801

2115 / 2121 WESTLAKE AVE
SEATTLE, WA 98121
PROJECT # 3037037 - EG

EARLY DESIGN GUIDANCE 2
DATE: 7/6/2021

ITEMIZED RESPONSE TO EDG #1 - BOARD RECOMMENDATIONS

PREVIOUS 3 MASSING CONCEPTS - EDG 1

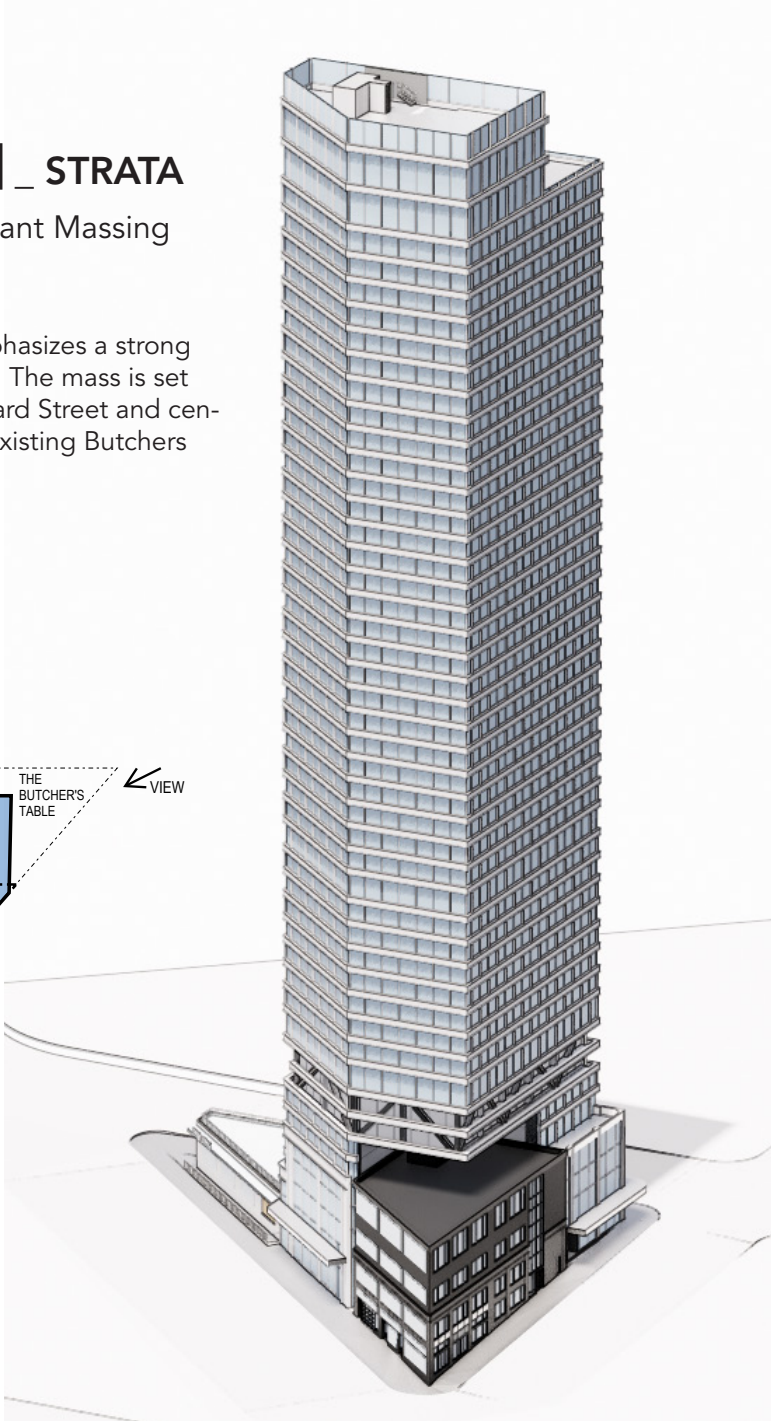
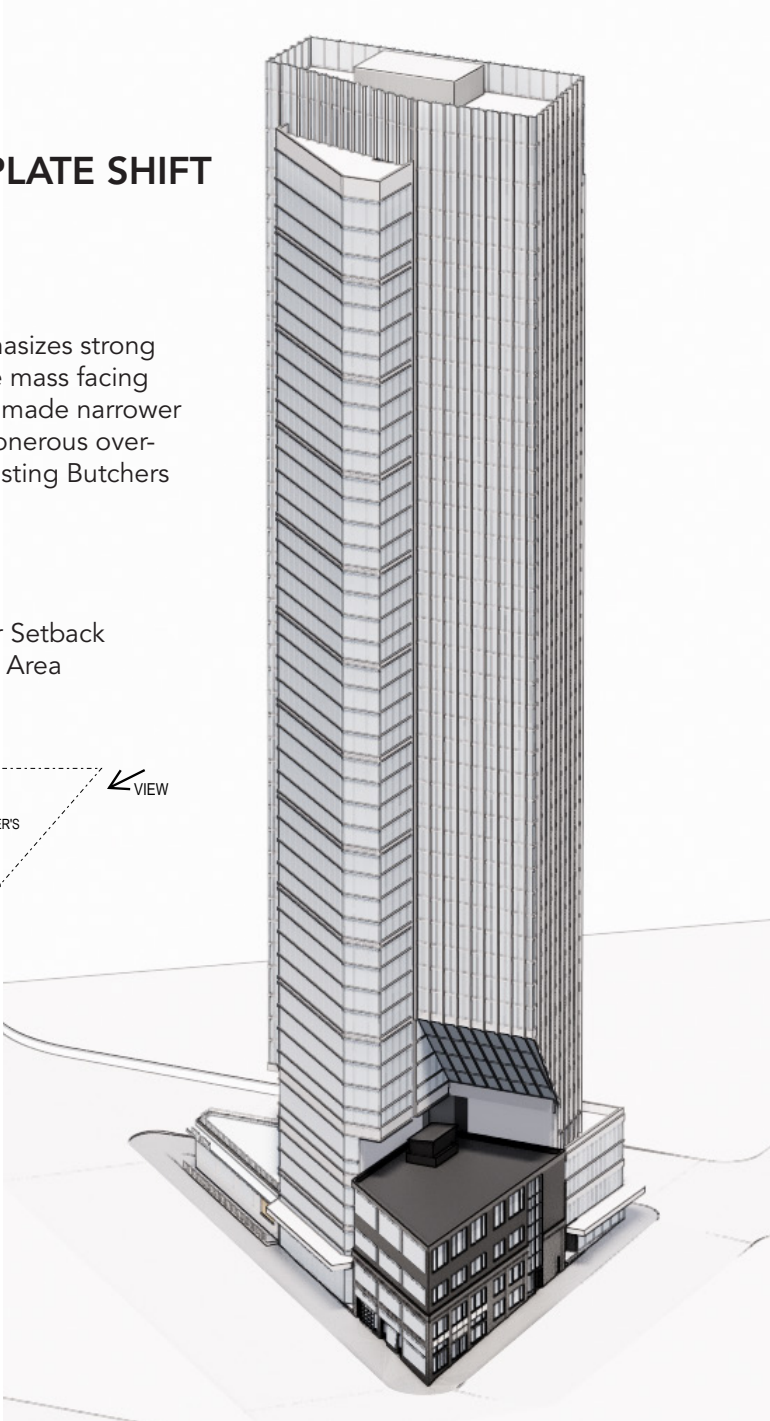
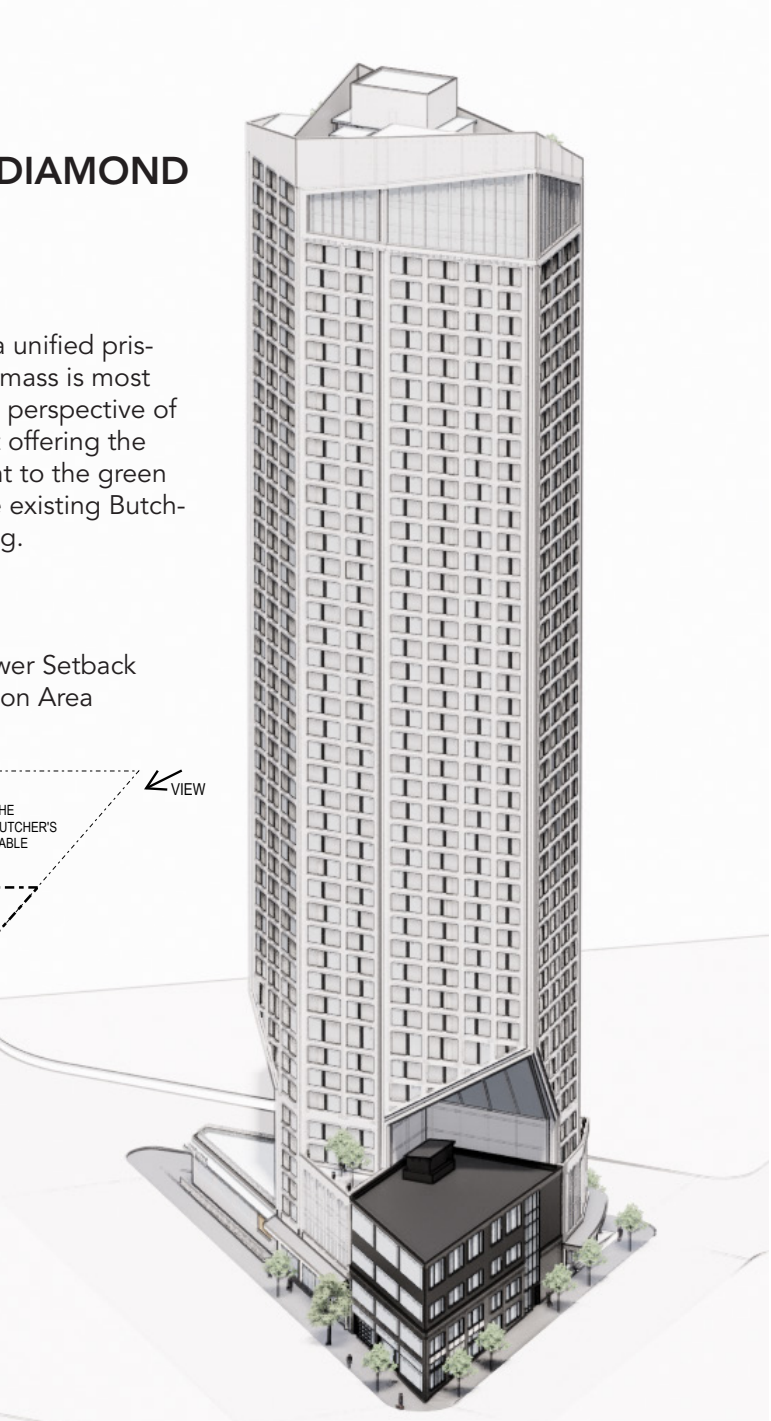
Guidance	
	MASSING AND ARCHITECTURAL CONCEPT	
1. a.	After considering the three massing options, architectural concepts, site constraints and response to context, the Board ultimately recommended the project return for a second EDG meeting. The Board requested that two or three massing options be prepared in response to guidance. (A-1, B-1, B-3, B-4)	Following the board' guidance, the design team has prepared two revised massing options, which are referred to as Concept 4, the Revised Diamond, and Concept 5, Fulcrum.

b.	<p>The Board evaluated the merits of each architectural concept, but did not support the execution of any singular concept in its entirety. The Board specifically prioritized Downtown Design Guidelines A-1, Respond to the Physical Environment, and B-1, Respond to the Neighborhood Context.</p> <p>i. The Board noted that the Option 2 "plate shift" concept results in the most geometrically simple form and creates the perception of a slender tower from several vantage points along Westlake Ave, whereas Option 1 and Option 3 are too bulky; in part because Option 1 appears to be an expression of the zoning envelope.</p> <p>ii. The Board noted that the Option 3 "diamond" concept has potential, but was concerned that it broadens the mass and contributes to the perception of bulk. (A-1, B-1)</p>	<p>The intent of Concept 4 is to improve upon Concept 3 by incorporating the merits of Concept 2 as noted by the board-geometric simplicity creating the perception of a slender tower from several vantage points along Westlake Ave.</p> <p>Concept 4 proposes a faceted plan shape as a response to the nonstandard shape of the block and the predominance of adjacent tower plan forms that are curved, faceted or pivoted with the street grid caused by Westlake Ave. (A-1.1.a.; B-1,d.) McKenzie, Enso, Stratus and Amazon Re-invent are such influential buildings.</p> <p>The massing has been modified to have 2 building skin expressions. These skins alternate and emphasize the tower as a series of vertical segments, rather than as a monolith. An additional vertical offset has been added at the 8th Street elevation which was previously bulky in appearance. The modifications are intended to reduce the perception of bulk and create the appearance of slender vertical forms (B4.1), especially from significant vantage points along Westlake Avenue (A-1.1.f.)</p> <p>Concept 5 is a entirely new massing proposal. The concept seeks to incorporate merits of the previous schemes, address priority Guidelines raised by the Board, and to fully comply with the Upper-Level Setback along the Blanchard Green Street.</p> <p>Concept 5 equally distributes the tower mass on each side of the triangular block. The non-standard shape of the block and the intersection of 3 streets is echoed in the building form which is characterized by 3 vertical masses interlocked in a triangle or 'pinwheel'. (A-1.1.a.) The massing yields slender vertical profiles from multiple vantage points. (B-1,d.)</p>

-Board appreciated Option 2 “Plate Shift” for creating the perception of a slender tower from several vantage points.

-Board appreciated potential of Option 3 “Diamond”; but concerned that it broadened the mass and perception of bulk in north south direction.

-Two massing options in response to the Board’s guidance: Concept 4 and Concept 5.

CONCEPT 4_ 3 Base and Street

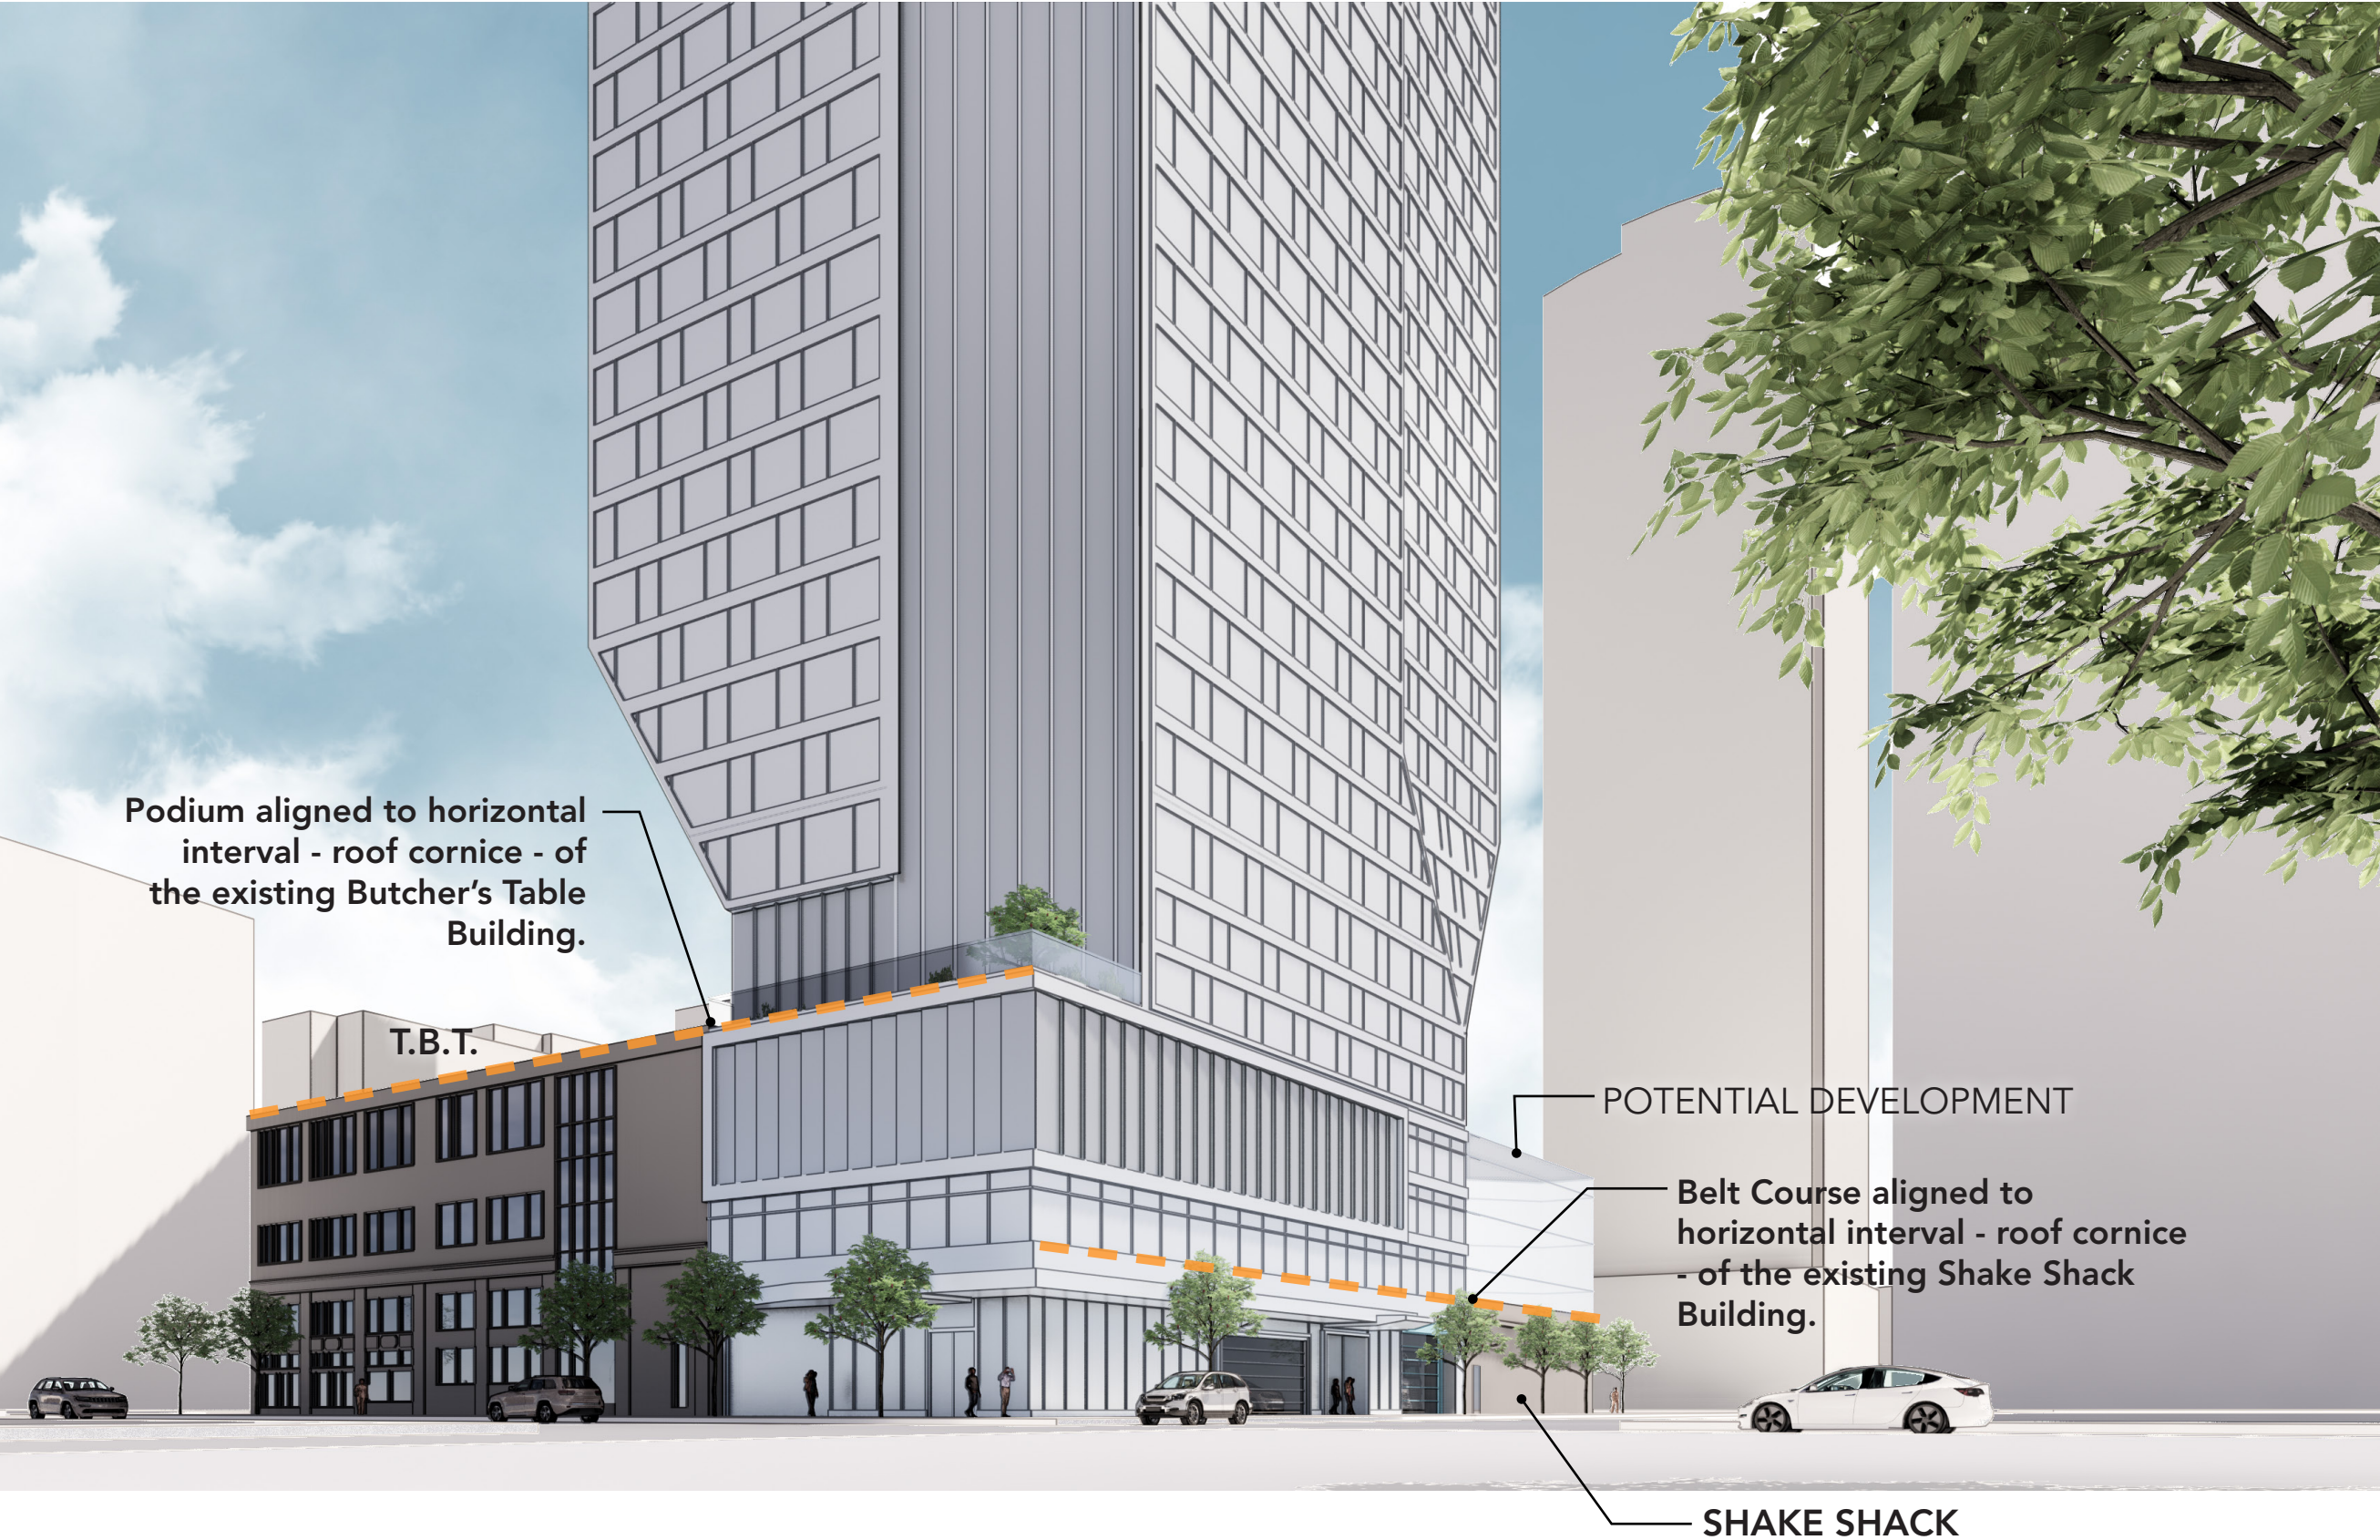
e.	e. The Board noted that the base of Option 1 and Option 3 better responds to the horizontal datums and scale of existing development along Westlake Ave and at the west corner, whereas Option 2 reads as a continuous flat plane from top to bottom. The Board recommended further study of how the scale of the base responds to the neighborhood context, is informed by the overall concept, and highlights the corner entry. (B-1, B-2.2, B-3, B-4)	<p>In both Massing Concepts, the base building shape is aligned to horizontal intervals of the existing buildings on the block. (B2.2) The western facade features a roof line aligned to the Butchers Table cornice and a belt course which continues the Shake Shack 1-story datum. (B-2.2.h.; B-3.2)</p> <p>In Concept 5, to further mitigate the bulk of the tower at the base, the facade is gradually modified with deeper recesses and expressed frames (B2.2h.; B-2.3.n.) modulated in sizes similar to the existing buildings.</p>

-Preference for horizontal datums matching existing buildings on the block

-Overhead weather protection should be integrated

The base of the building emphasizes horizontal intervals relating to the existing buildings on the block. **(B2.2)** The western facade features a roof line aligned to the Butchers Table cornice and a belt course which continues the Shake Shack 1-story datum. **(B-2.2.h.; B-3.2)**

Overhead weather protection is provided at pedestrian entries on 8th and Blanchard, and on Westlake to align with the Shake Shack’s adjacent canopy feature. **(B3.3 C-5)**
